STAFF RECOMMENDATION 1904 Sweetbriar Avenue February 15, 2017

Application: New construction—outbuilding; Setback determination
District: Belmont Hillsboro Neighborhood Conservation Zoning Overlay
Council District: 18
Map and Parcel Number: 10416024300
Applicant: William Pressler, owner
Project Lead: Melissa Sajid, melissa.sajid@nashville.gov

Description of Project: The request is to construct a nine hundred and ninety square foot (990 sq. ft) outbuilding at the rear of the lot. The structure requires a rear setback determination from twenty feet (20') to five feet (5'). The outbuilding does not include a dwelling unit.

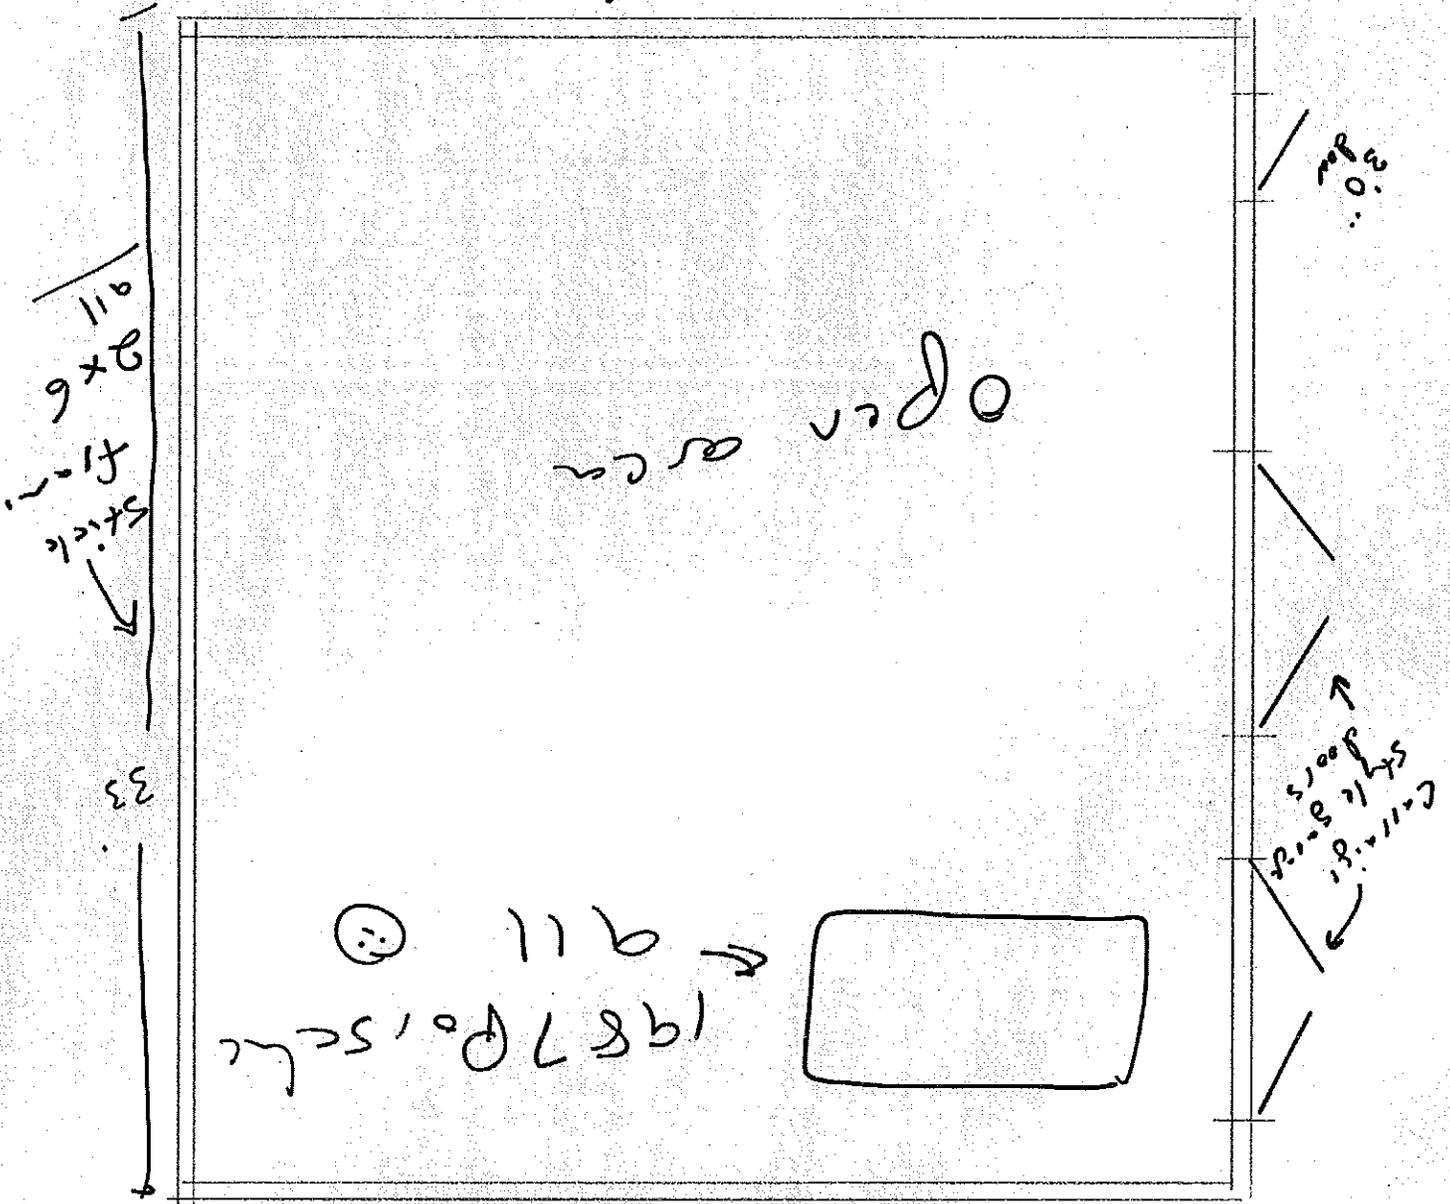
MINIMUM	PROPOSED
Space between principal building and DADU/Garage	20’	41’
Rear setback	20’	5’
L side setback**	5’	30’
R side setback**	5’	5’
How is the building accessed?	From the alley or existing curb cut	Alley

For outbuildings that have footprints that are larger than seven hundred square feet (700 sq. ft.), the base zoning setbacks are five feet (5') for the side and twenty feet (20') from the rear property line. In this case, the proposed outbuilding of nine hundred and ninety square foot (990 sq. ft) meets the side setbacks required by the base zoning but does not meet the required rear setback. The proposed outbuilding will be five feet (5') from the rear property line, which requires a rear setback determination.

Staff finds that the proposed five foot (5') rear setback to be appropriate because historically, outbuildings were situated close to the rear property lines. A five foot (5') rear setback is more historically appropriate than a twenty foot (20') rear setback. In addition, if the outbuilding were less than seven hundred square feet (700 sq. ft.), the base zoning rear setback would be just three feet (3') since the garage doors do not open directly to the alley. The reduced rear setback allows for more space in between the house and the outbuilding, which is appropriate. For these reasons, staff recommends approval of the rear setback determination.

With approval of the rear setback determination, staff finds that the project meets Section II.B.i.2 of the design guidelines.

Architectural
Sketch

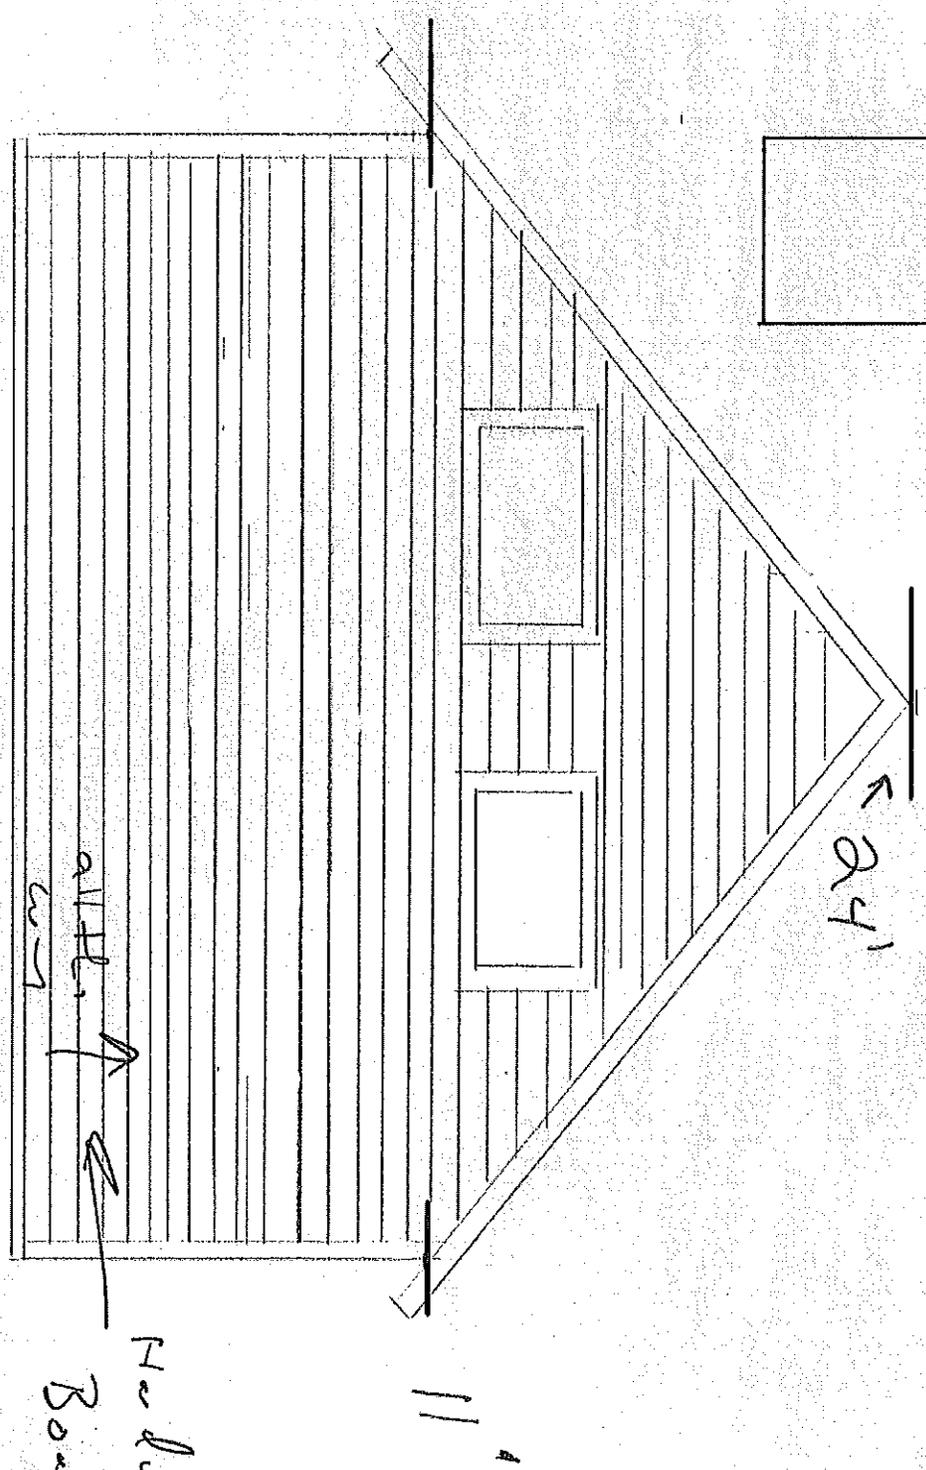
Existing conditions (height of historic portion of the home to be measured from finished floor)	Potential maximums (heights to be measured from grade)	Proposed (should be the same or less than the lesser number to the left)
Ridge Height	24'	25'	24'
Eave Height	11'-10"	10'	11'

The proposed detached garage is one story and does not exceed the maximum ridge height per the design guidelines. The average eave height for the outbuilding is taller than the maximum single-story eave height but does not exceed the average eave height of the historic house, which includes a two-story rear addition that was approved by the Commission in 2010. Since the average eave height of the outbuilding is close to a foot (1') less than the average eave height of the house and the building is

not required to follow the standards of a detached accessory dwelling unit since it will not be used as such, staff recommends approval of the proposed average eave height and, therefore, finds that the proposed outbuilding meets Section II.B.i.1. of the design guidelines.
